PLANNING, ZONING, & BUILDING DEPARTMENT
PZ&B Staff Memorandum: Landmarks Preservation Commission

SUBJECT: COA-23-003 (ZON-23-020) 139 N COUNTY RD—PARAMOUNT THEATER
(COMBO)

MEETING: APRIL 19, 2023 (LPC)
MAY 10, 2023 (TC)

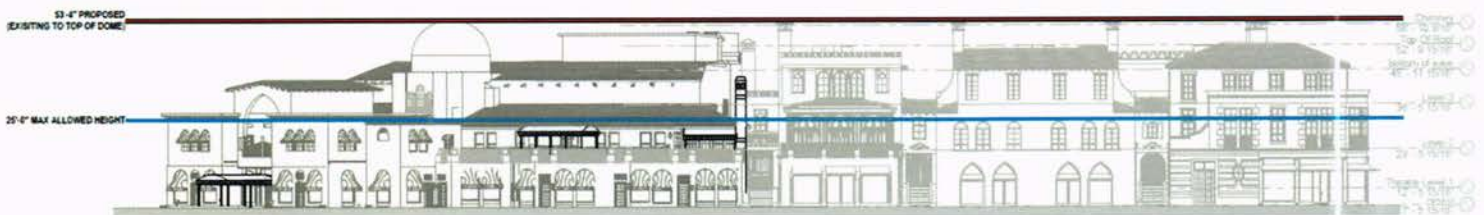
The applicant is proposing a two-level subterranean parking garage accommodating 127 parked vehicles (in a myriad of non-traditional parking methods) accessed off Sunrise Avenue. The garage is proposed with 127 spaces minus 85 spaces minus 5 spaces = resulting in a surplus of 37 parking spaces. 116 undergrounding parking spaces will be utilized to meet the parking demand for the existing Paramount Building and the proposed four (4) new homes; eight (8) of the parking spaces will be solely used by the owners, and two (2) of the spaces will be used only by the homeowners' guests. While the applicant is not deficient in provided parking space, and in fact, has surplus parking, it is imperative to note that the proposed garage structure requires three (3) setback variances (#12, 13, 14), the use of three non-traditional parking methods in the form of tandem, triple stacked, and mechanical lifts (#15), a reduction in the two-way drive aisle width (#17) and an increase in the maximum slope of the parking decks and ramps (#18). Staff has expressed serious concerns of the possible ramifications of the underground parking garage edifice as it pertains to vehicle and pedestrian safety. Staff recommends a redesign of the parking structure to reduce the variance requests.

② VARIANCE DIAGRAM - BUILDING HEIGHT DIAGRAM
1/16" = 1'-0"

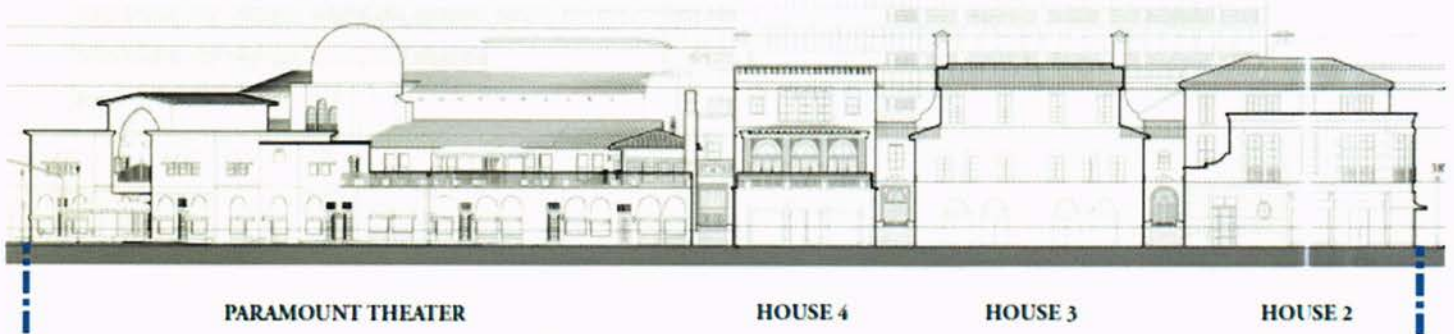
As it pertains to variances #5 and #6, a variance to exceed the maximum building of 25' and the maximum overall building height of 30', these two requests are fundamentally linked to variance #4. Should the Town Council find merit in the request for an additional story, then these variance requests would follow confirming that the proposed building heights of the new homes are appropriately scaled for the adjacent Paramount building and the surrounding neighborhood.

That said, when viewing the context of the proposal in relation to the landmarked three-story building and more importantly the two-story liner component of the theater, there are considerable opportunities to lower the heights of the new residences to be more in scale with its immediate context, ie the two-story commercial liner of the Paramount.

As proposed, the second floor of the new residences contain a capacious 13' floor to ceiling height which is inappropriate for the historical context. Currently, the proposed new construction will be taller than the vaulted expanse of the auditorium of the theater yet be below only the signature dome of the landmarked building.
